June 30, 2015
Serial: MNS-15-026

Duke Energy Carolinas, LLC (Duke Energy)
McGuire Nuclear Station, Units 1 and 2
Docket Nos. 50-369 and 50-370
Renewed License Nos. NPF-9 and NPF-17

Subject: License Amendment Request for Temporary Changes to Technical
Specifications for Correction of an 'A' Train Nuclear Service Water System
(NSWS) Degraded Condition

Figure 9: Personnel Access Manway and SNSWP Isolation Flange Detail

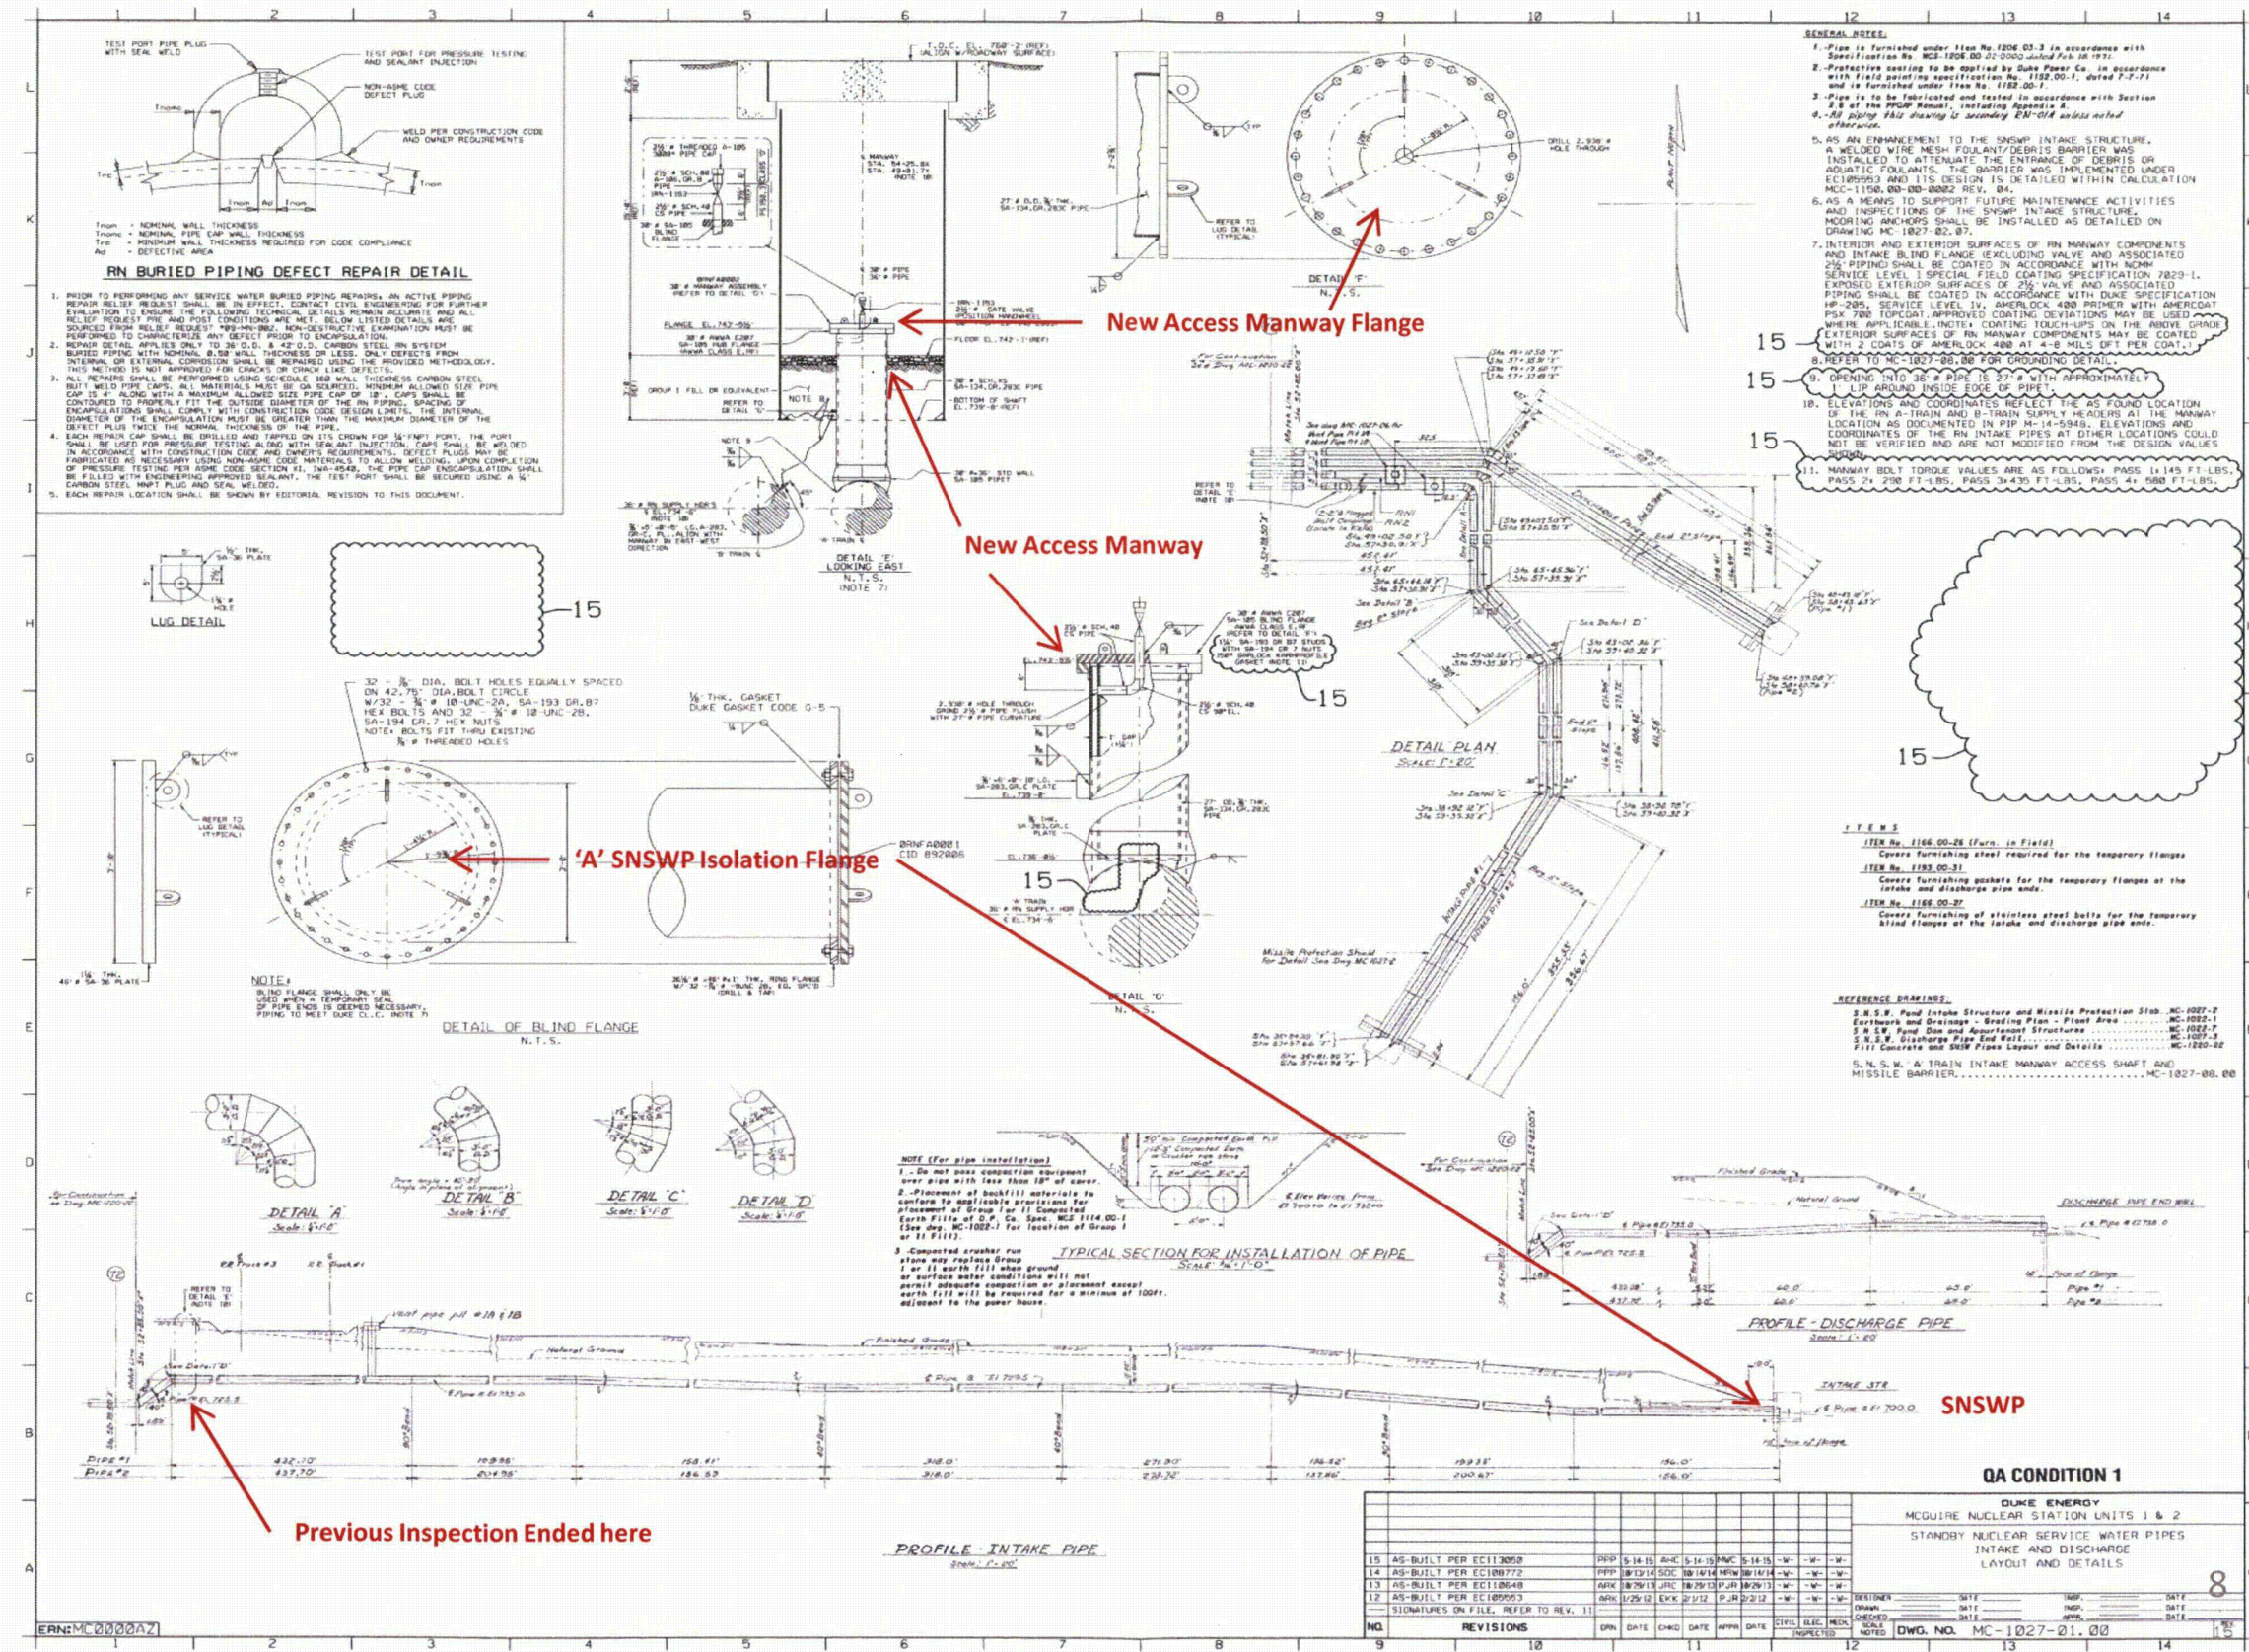
The SNSWP end of the 'A' Train NSW pipe will be isolated by the installation of a bolted blank flange on the end of the pipe suction. The flange is designed and constructed to meet ASME requirements. A plant drawing of the flange can be found in Figure 9: Personnel Access Manway and SNSWP Isolation Flange Detail in Attachment 4 of this submittal. Once isolated by ORN-7A, the piping will be drained by pressurizing with air through a vent to push the water in

the pipe toward and out of the pipe at the SNSWP. Once the water from the piping has been evacuated, the flange will be installed. Once the flange is installed, the pipe will be vented for opening of the existing pre-installed access manway. In an activity planned to be performed this summer separate from the 14 day completion time repair activity the SNSWP isolation flange will be test fitted to the 'A' SNSWP pipe.
